NPCC Request for Criteria Clarification

Request for a Clarification of Criteria
Date submitted: December 1, 2017 Date revised version submitted: n/a
Contact information for person requesting the clarification:
Name: Alan Adamson
Organization: New York State Reliability Council (NYSRC) Reliability Rules Subcommittee
Telephone: 352-989-4653
E-mail: aadamson@nycap.rr.com
Identify the Directory that contains the Criteria requiring clarification:
Directory Number: Directory 1
Directory Title: Design and Operation of the Bulk Power System

Figure 1

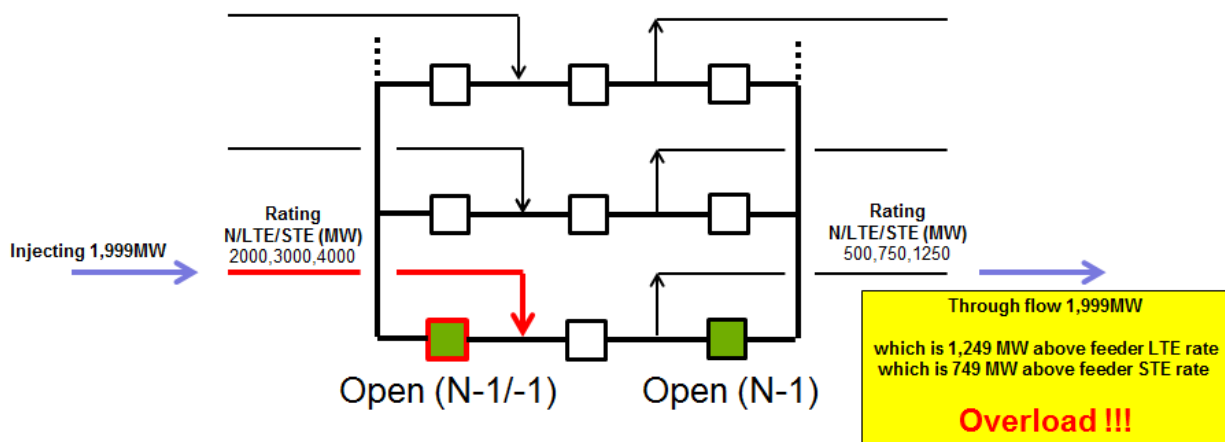
Under such N-1/-1 events, a high capacity injection (ex.: AC transmission, HVDC, or a generating unit) can be isolated onto a low rated transmission circuit (possibly loading it above its LTE or even its STE rate). Please see Figure 1 below:

1. Why does NPCC Directory 1 omit N-1/-1 event such as open breaker followed by an open breaker?

A possible solution to the identified scenario above (Figure 1)* could be to open the middle breaker as a "system adjustment" within 30 minutes before the second contingency (in effect tripping the low rated transmission circuit). This action would eliminate the postulated overload illustrated in Figure 1.

2. Does NPCC Directory 1 postulate that the opening up of a circuit breaker falls within the definition of a "system adjustment"?
